# UNITED STATES PATENT AND TRADEMARK OFFICE

## Office Action Summary

This is the second Office Action for the serial number 10/714,003, CABLE CLAMP, filed on 11/14/03.

See diagram of Stoneburner shown below for clarification.

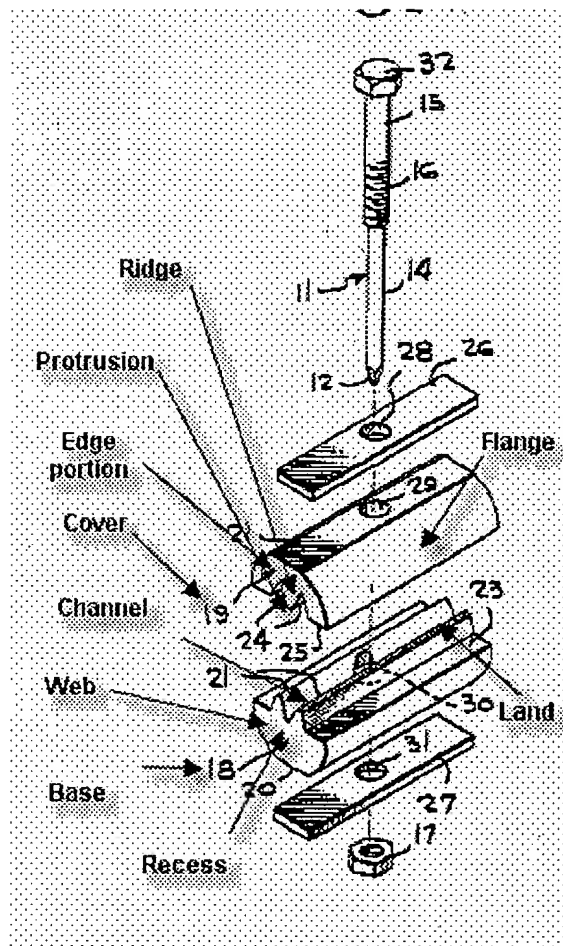
Stoneburner teaches a cable clamp comprising a base (18) including a block of a longitudinal length greater than its transverse width. The block has an upwardly open channel (located between element 21) extending the longitudinal length thereof. The channel having a web surface (located between the walls of element 21) and transversely spaced side walls (21), longitudinally spaced recess (depression part of web) opening upwardly through the web surface and transversely spaced lands (located on top of element 21) that at least in part define the channel side walls. The clamp comprises a longitudinally elongated cover (19) having a top wall with perimetric edge portions, flanges (25) dependingly joined to the top wall edge portions and having transversely opposite longitudinally elongated portions. The cover comprises a longitudinally elongated ridge (located between element 24) dependingly joined to the top wall in transversely spaced, transversely centered relationship to the flange longitudinal portions. The cover ridge being extendable into the base channel and having protrusion (tapered part of

Stoneburner teaches the base having recess and the cover having protrusion but fails to teach the base having plurality of recesses and the cover having more than one protrusions. Down shows cover having plurality of protrusions and base having plurality of recess (figures 5-6). It would have been obvious for one of ordinary skill in the art at the time the invention was made to have modified Stoneburner's base with plurality of recesses and cover with plurality of protrusions as taught by Down to provide a separate path of cables or ropes to avoid them from tangle up when clamping the cover and base together.

Stoneburner teaches the base and cover having vertically aligned mounting screw aperture but fails to teach the base and cover having additional vertically aligned mounting screw apertures. Down teaches two vertically aligned mounting screw apertures (figure 6). It would have been obvious for one of ordinary skill in the art at the time the invention was made to have added additional vertically aligned mounting screw aperture to Stoneburner's base and cover as taught by Down to provide additional security for retaining the cable or rope in the clamp.

between element 21) extending the longitudinal length thereof. The channel having a web surface (located between the walls of element 21) and transversely spaced side walls (21), longitudinally spaced recess (depression part of web) opening upwardly through the web surface and transversely spaced lands (located on top of element 21) that at least in part define the channel side walls. The clamp comprises a longitudinally elongated cover (19) having a top wall with perimetric edge portions, flanges (25) dependingly joined to the top wall edge portions and having transversely opposite longitudinally elongated portions. The cover comprises a longitudinally elongated ridge (located between element 24) dependingly joined to the top wall in transversely spaced, transversely centered relationship to the flange longitudinal portions. The cover ridge being extendable into the base channel and having protrusion (tapered part of elongated ridge) in about the same longitudinal spaced relationship as the recess. The cover and base being secured by fasteners (32,17). The base and cover have vertically aligned mounting screw aperture (29-30).

Applicant's arguments with respect to claims 1-6, 9, 16, 18-23 have been considered but are moot in view of the new ground(s) of rejection.
